December 23, 2015

**Re: Site Investigation Report  
Martino's Master Dry Cleaners  
3917 52<sup>nd</sup> Street  
Kenosha, Wisconsin 53144  
BRRTS# 02-30-552186**

**WATER TABLE CONTOUR MAP  
 WITH ALL WELLS MAPPED  
 JUNE 2015  
 Martino's Cleaners  
 3917 52nd Street  
 Kenosha, Wisconsin**

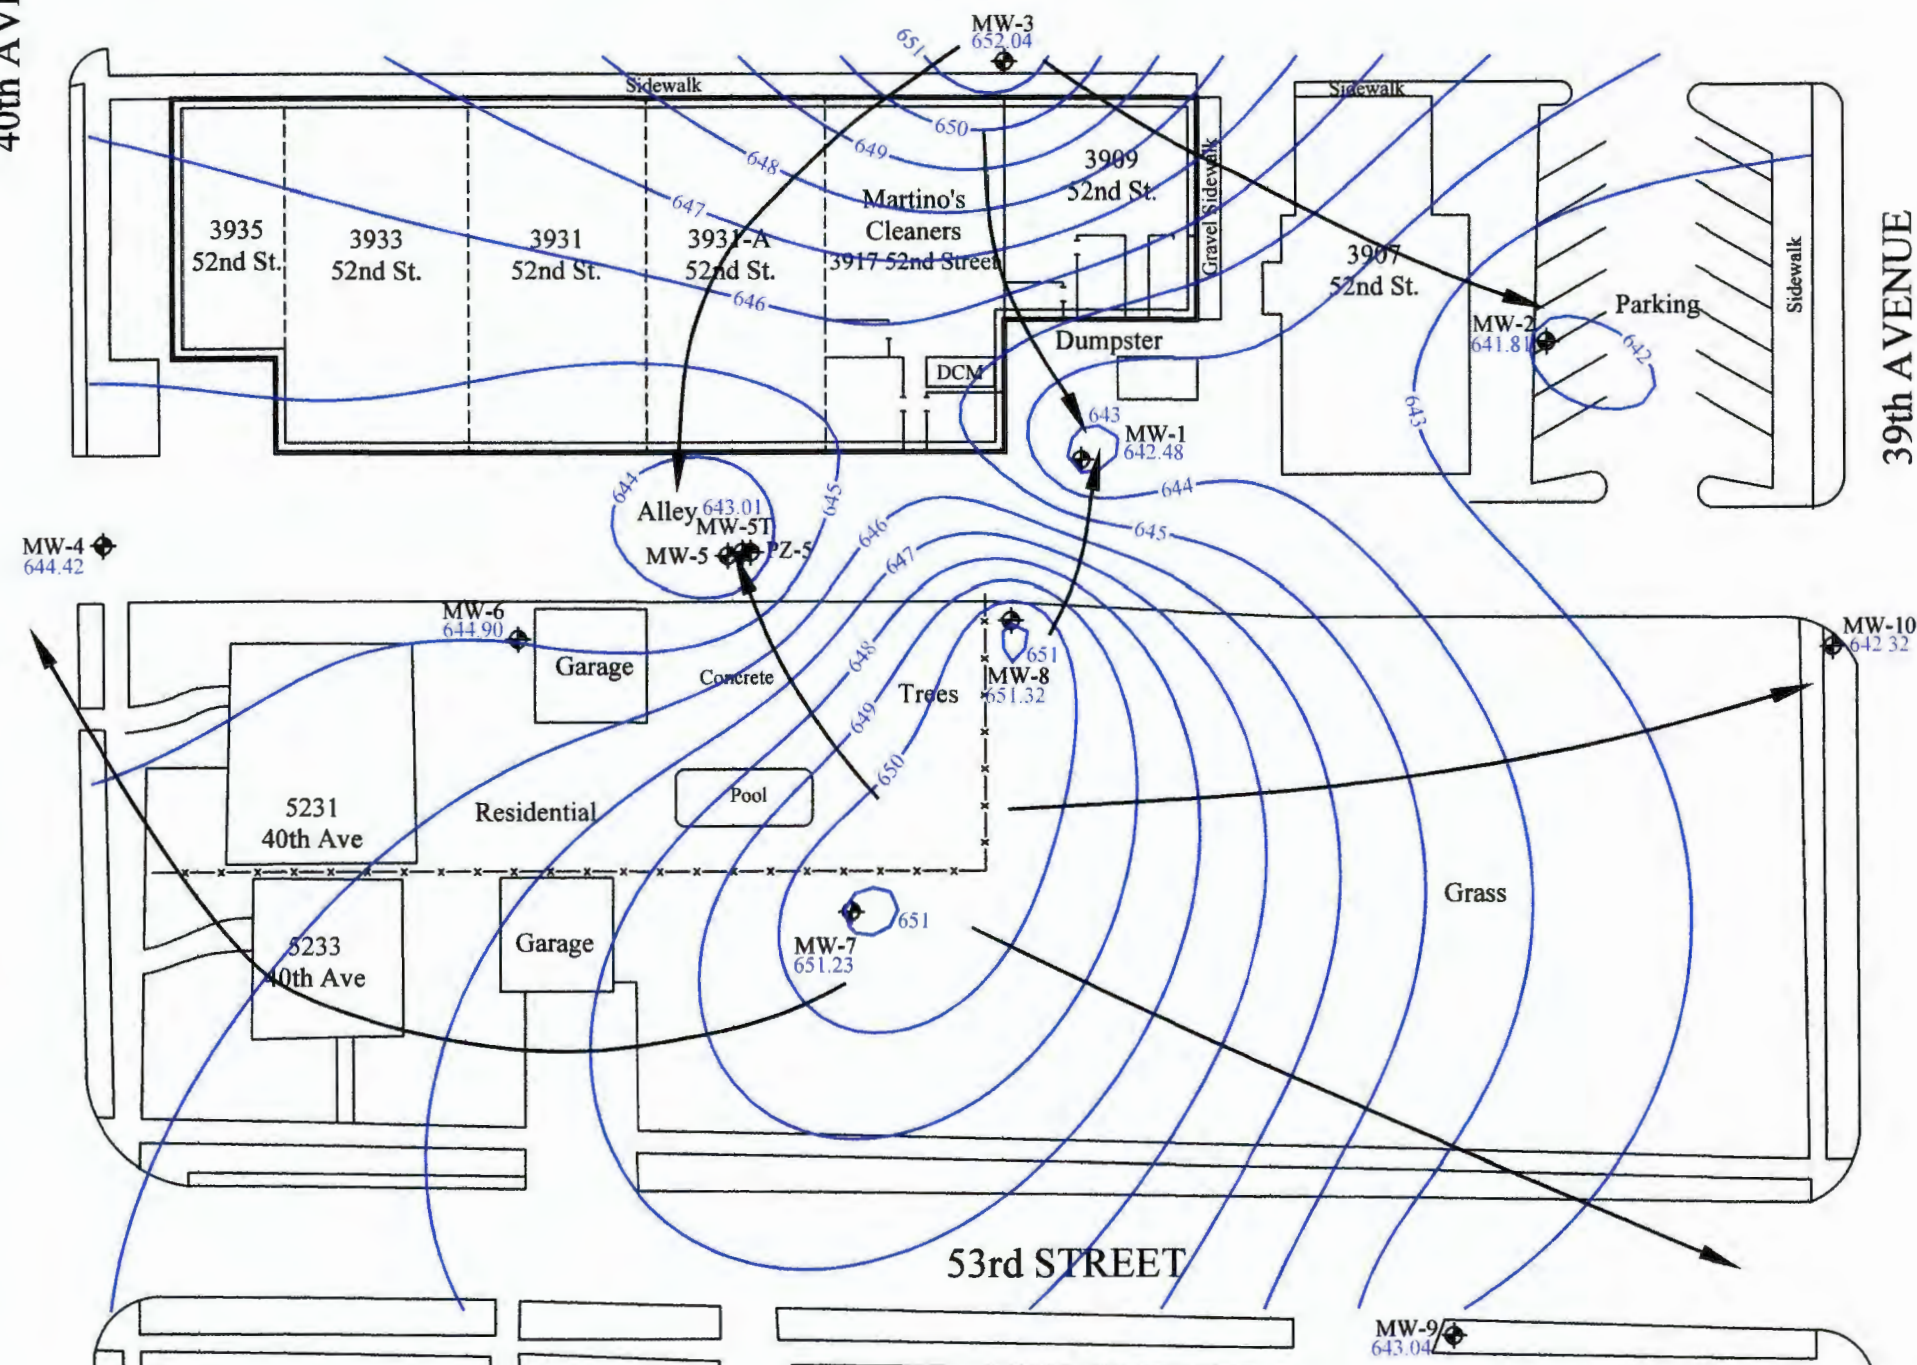
**Bullet #5:** A shallow 2-4 ft. and deeper 8-10 ft. groundwater flow system has been identified at the site. Please map the occurrence of each and explain how they contribute to contaminant migration.

**EnviroForensics Response #5:** Depth to water in most wells has fluctuated between 10 to 15 feet below ground surface seasonally. However, in wells MW-3, MW-7, and MW-8 static groundwater levels are within two feet of ground surface. These non-conforming water levels when mapped with all other wells do not exhibit a continuous groundwater flow field, but instead skew groundwater flow in all directions away from the measured high water levels (see attached Figure 12).

The non-conforming water levels may be due to the geology at this site, which is a complex assemblage of discontinuous layers, lenses, and seams of sand, silt, and clay that are not well sorted. This is soil typically deposited by glacial action. There is also a layer of fill 3-5 feet thick along the alleyway that appears to continue to a lesser thickness under the commercial building. It is not unusual in this type of depositional environment for there to be zones of perched water. It is also not unusual under these conditions for static water levels to yield a potentiometric surface map without definitive or continuous groundwater

flow directions, given that fine clay and silt soils drain slowly and at different rates after precipitation events

EnviroForensics does not feel that further investigations to determine exact hydraulic linkages or mapping of the existing data is practical or needed for remedial planning, and in this type of depositional environment may not even be possible. Groundwater impacts appear to be limited in both depth and lateral extent, and not migrating extensively. We will likely implement actions to treat the higher concentrations in groundwater, along with removal of highly contaminated soil in the source area. Remaining residual groundwater impacts will likely be monitored for natural attenuation.
